# Access Compliance Report

## Public Rights-of-Way

Intersection ID: 10027438	Main Street: GOODMAN PARK CT	Cross Street: N/A	Location: NE
ADA ID: 07AB045FC3D3	Ramp Type: Perp	Initial Pass/Fail: Fail	Overall Compliance: No Severity Score: 33.75

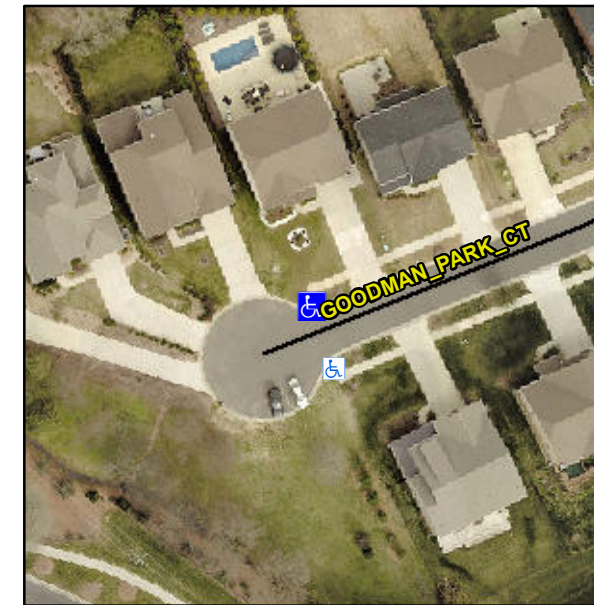
**Not Found, R304.5.1, R304.2.2**

Compliance	Description	Data	Compliance	Description	Data
N/A	Ramp Length (in)	97.0	No	Ramp Slope (%)	12.3
No	Ramp Width (in)	47.5	Yes	Ramp XSlope (%)	2.0
N/A	Flare Type LT	N/A	N/A	Flare Type RT	N/A
N/A	Flare Slope LT (%)	N/A	N/A	Flare Slope RT (%)	N/A
N/A	Flare Traversable LT?	N/A	N/A	Flare Traversable RT?	N/A
N/A	Landing Length (in)	N/A	N/A	DWS Provided?	N/A
N/A	Landing Width (in)	N/A	N/A	DWS Contrast?	N/A
N/A	Landing Slope (%)	N/A	N/A	DWS Length (in)	N/A
N/A	Landing X Slope (%)	N/A	N/A	DWS Full Width?	N/A
N/A	Landing Curb? (Y/N)	N/A	N/A	DWS Offset (in)	N/A
N/A	Shared Landing?	N/A			
N/A	Gutter Ponding?	N/A	N/A	Gutter Slope (%)	N/A
N/A	Gutter Lip Ht (in)	N/A	N/A	Gutter X Slope (%)	N/A
N/A	Painted X Walk1?	No	N/A	Painted X Walk2?	N/A
	X Walk 1 Direction	To S		X Walk 2 Direction	N/A
N/A	X Walk 1 Width (in)	N/A	N/A	X Walk 2 Width (in)	N/A
	X Walk 1 Slope (%)	2.4		X Walk 2 Slope (%)	N/A
	X Walk 1 X Slope (%)	1.8		X Walk 2 X Slope (%)	N/A

**Remove & Replace Entire Ramp.**
